***TECHNICAL SPECIFICATIONS
PUBLICATIONS LIST
RECALL CAMPAIGN
SERVICE BULLETIN INDEX***

**328 / 328
GTB / GTS**

Ferrari Servizio Assistenza Tecnica

FERRARI NORTH AMERICA

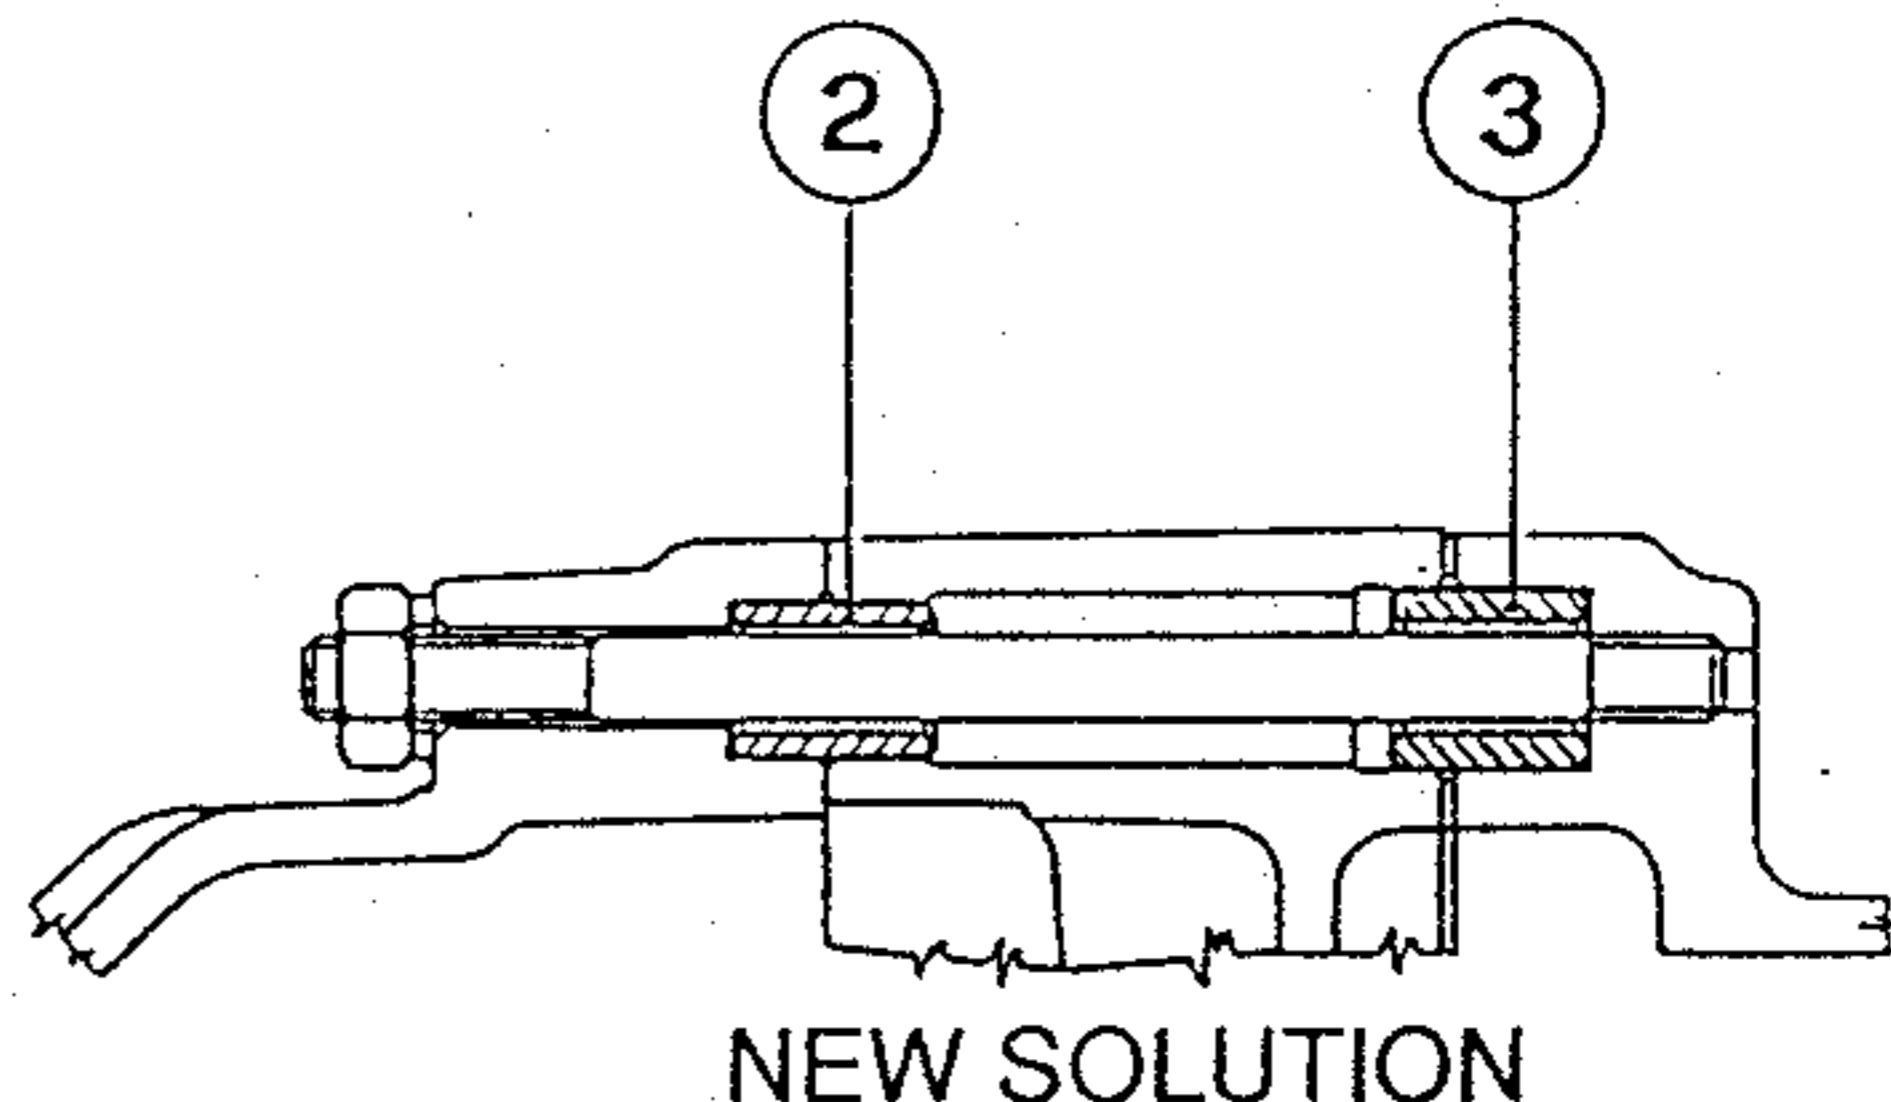
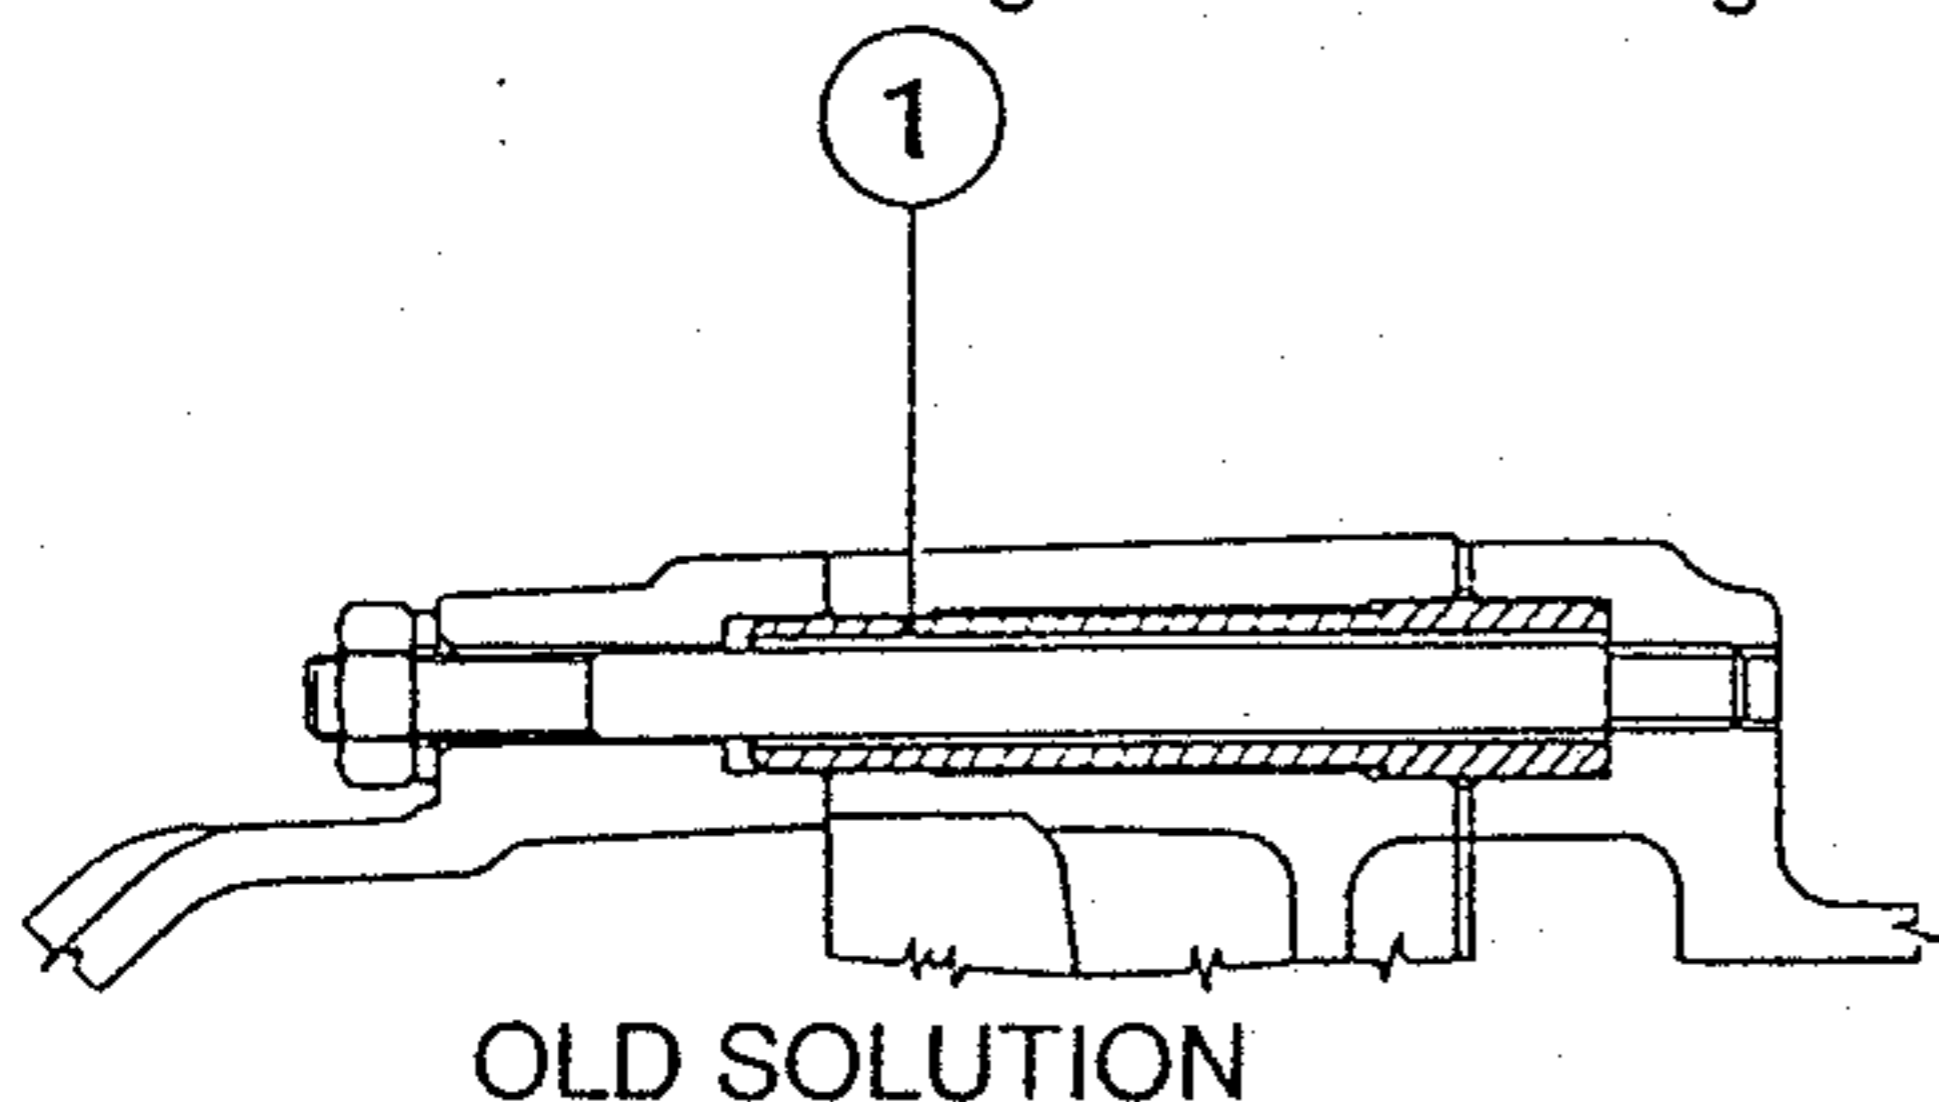
Description: The intermediate casting is installed by means of 2 centering dowels instead of one on the gearbox housing and the crankcase.

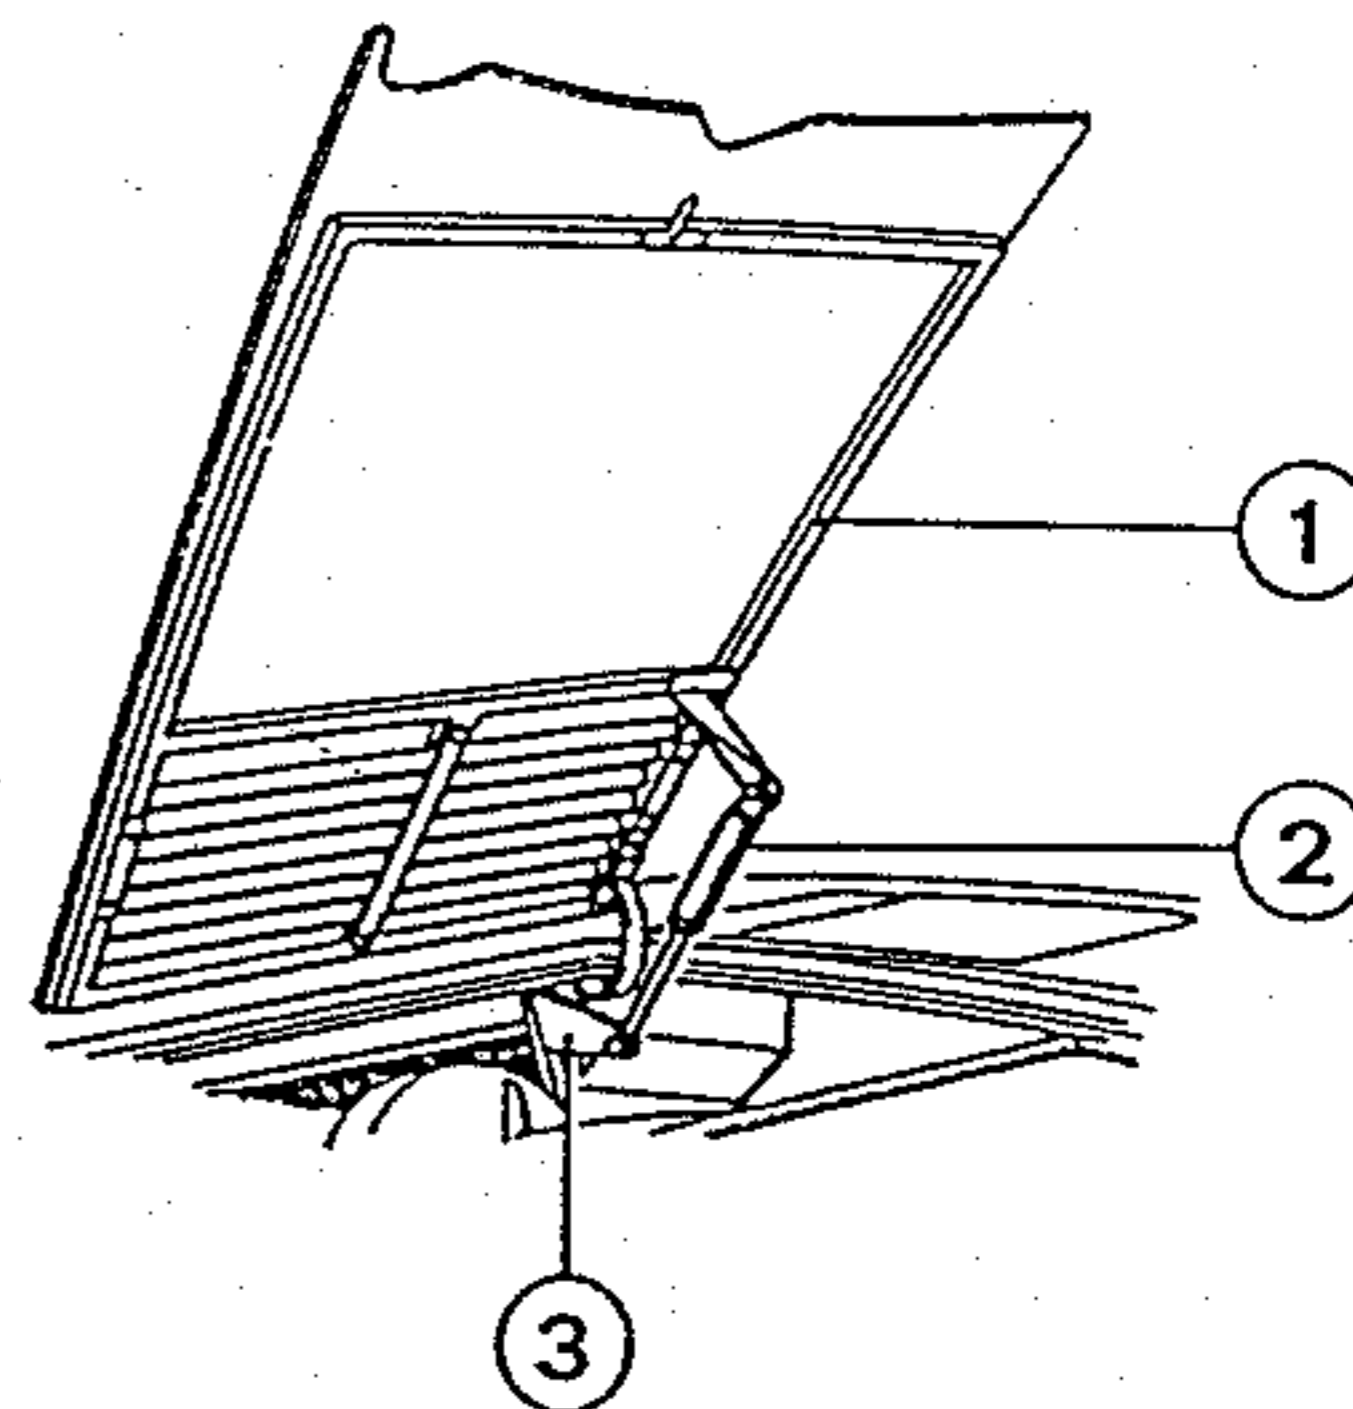
A new bonnet is assembled having a new support located on the right hand side instead of the previous left hand side.

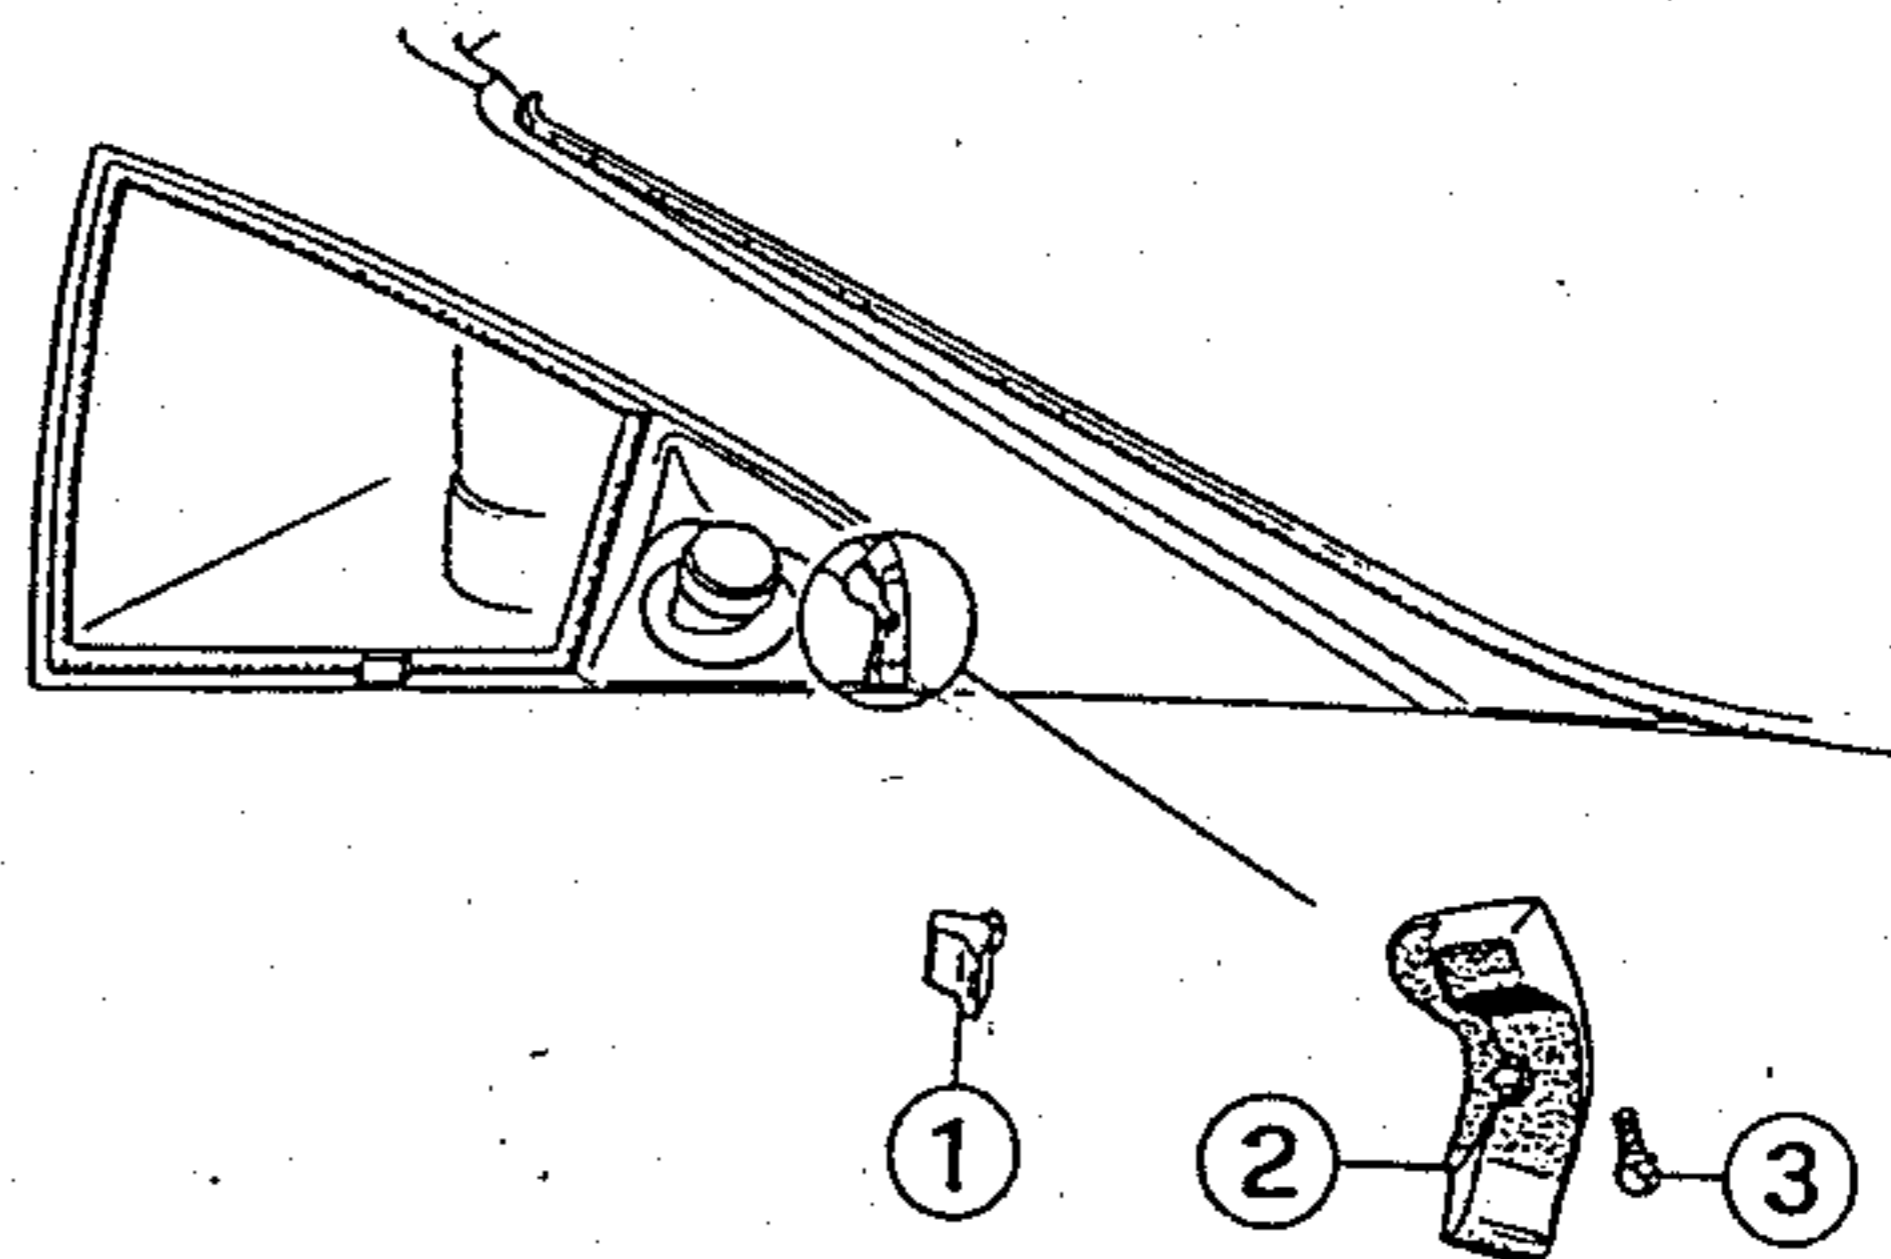
The left side grill grommet is of a new design.
